Final Work Plan for Contamination Delineation at Remedial Unit C5

**Hunters Point Shipyard
San Francisco, California**

**November 2005
Revision 0**

**DEPARTMENT OF THE NAVY
Base Realignment and Closure
Program Management Office West
1455 Franzee Road, Suite 900
San Diego, California 92109**

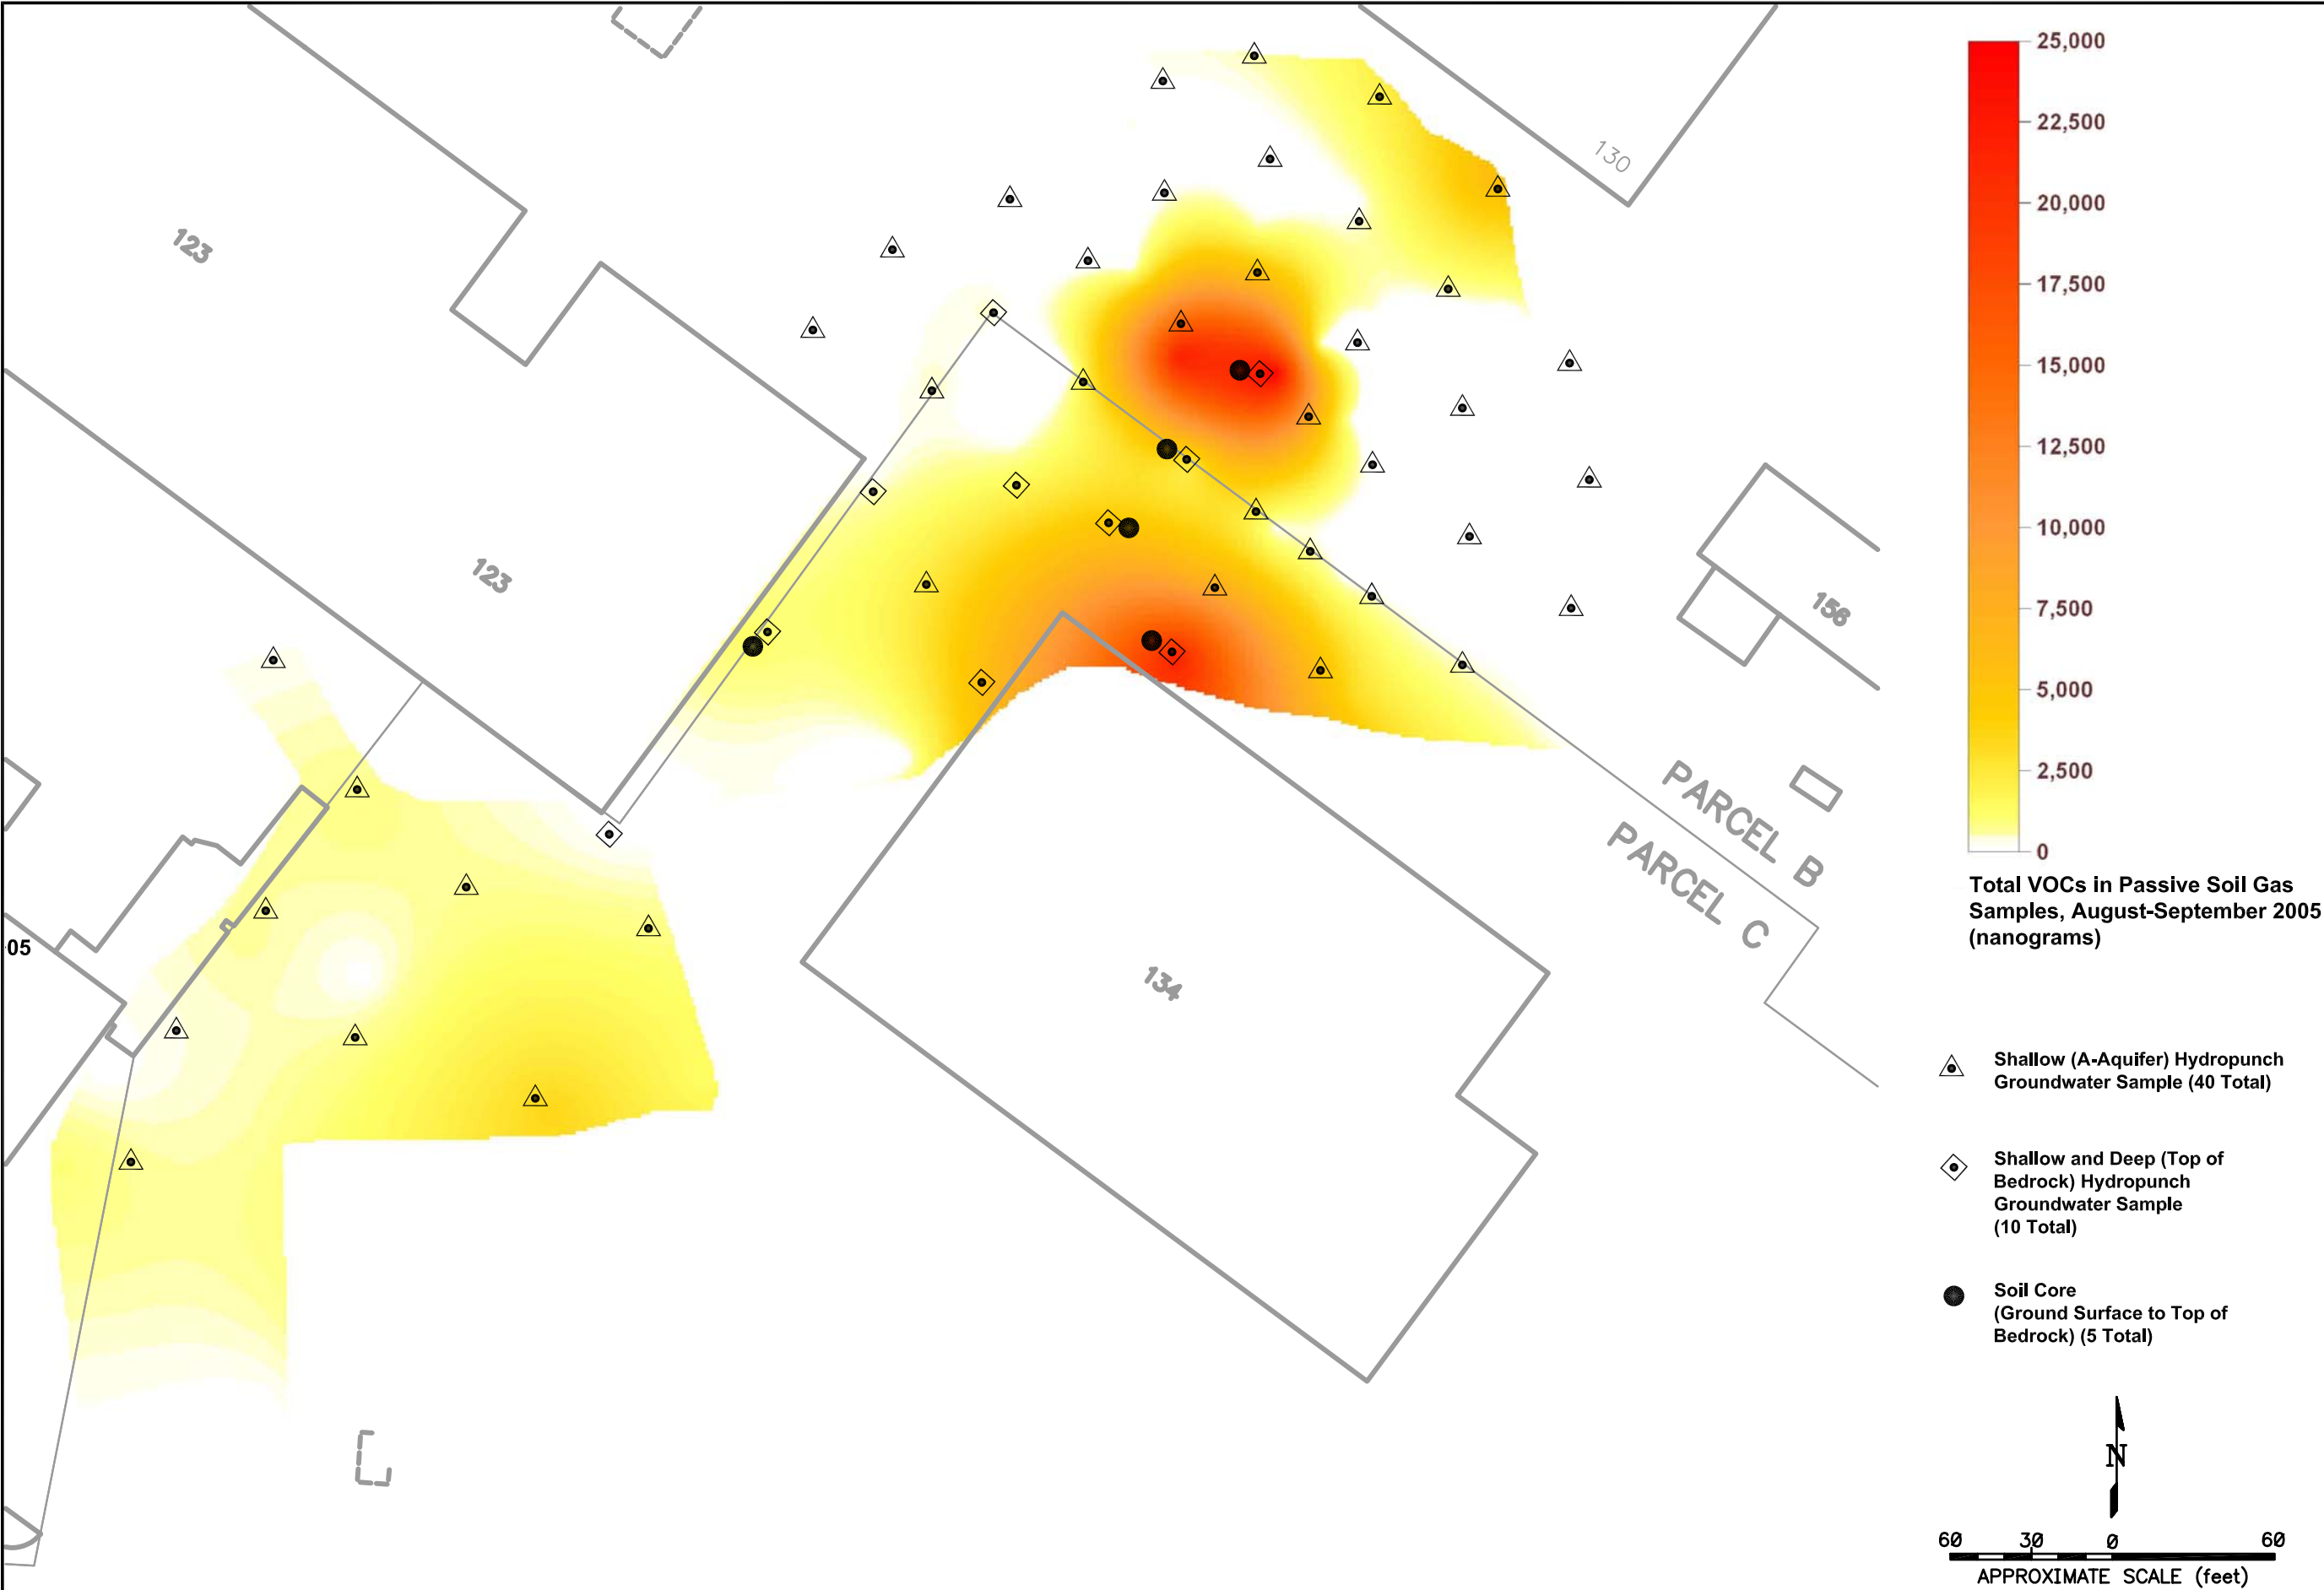
1. One of the objectives of the proposed investigation is to “Delineate the horizontal extent of VOCs in Parcel B adjacent to RU-C5 if the investigation indicates that contaminants from this area have migrated across the boundary into Parcel B” (Draft Work Plan page 1-1, and Draft Sampling and Analysis Plan [SAP] page 1-5) in two phases to “better define VOC contamination along and on either side of the Parcel Boundary,” but the figure provided in the Work Plan does not support the objective stated in the text. Figure A-5 shows the proposed Phase A soil gas sample locations situated either along, or on both sides of, the boundary separating Parcels B and C, but most of the proposed Phase B soil gas sample locations (with the exception of the locations to the north of Building 134) are situated on the Parcel C side of the boundary. Since the investigation objective is to delineate volatile organic compounds (VOCs) that have migrated “across the boundary into Parcel B” it appears that more of the Phase B locations should be installed on the “B” side of the parcel boundary. Please move most of the Phase B sample locations to the Parcel B property, or explain why the samples should be collected on the C side of the parcel boundary.

Response: The suggested sampling locations have been included on Figure A-14. This figure was provided to the regulatory agencies prior to finalizing this Work Plan.

Response: The suggested sampling locations have been included on Figure A-14. This figure was provided to the regulatory agencies prior to finalizing this Work Plan.
